AMENDMENTS TO THE DRAWINGS

ANNOTATED SHEET

Title: SELF-CONTAINED ARTICULATED MATTRESS
Ser. No.:

Fig. 6

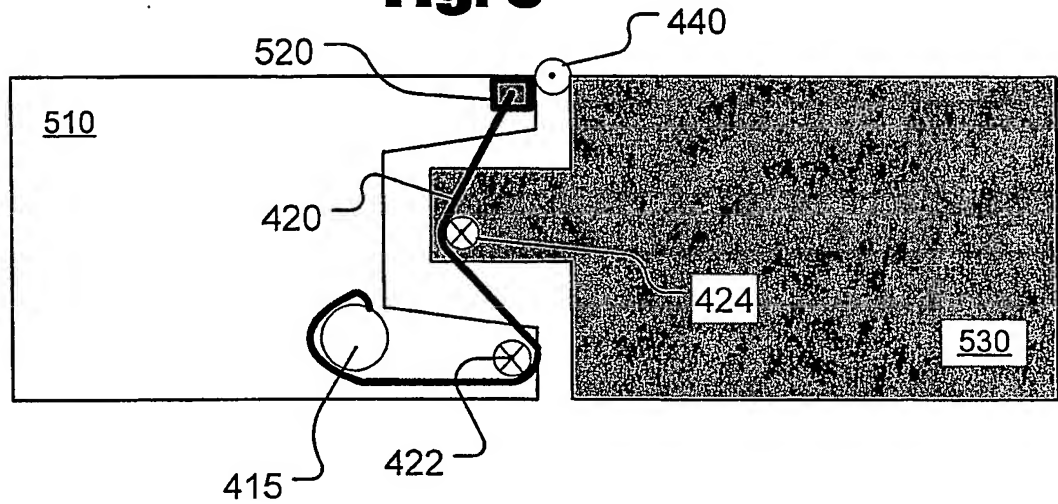
The attached replacement sheet 5/5 of drawings replaces original sheet 5/5 with Figs. 5 and 6, and includes changes to Fig. 6. The mattress is now shown as "640", the cover as "610", and the sleeping surface as "612." The specification has been amended accordingly.

The drawings are objected to for failing to comply with 37 CFR 1.84(p)(4) because the reference character "640" has been used to designate both cover and mattress in Fig. 6. This objection has been addressed by amending Fig. 6 and paragraph [0045] of the specification. Withdrawal of the objection is respectfully requested.
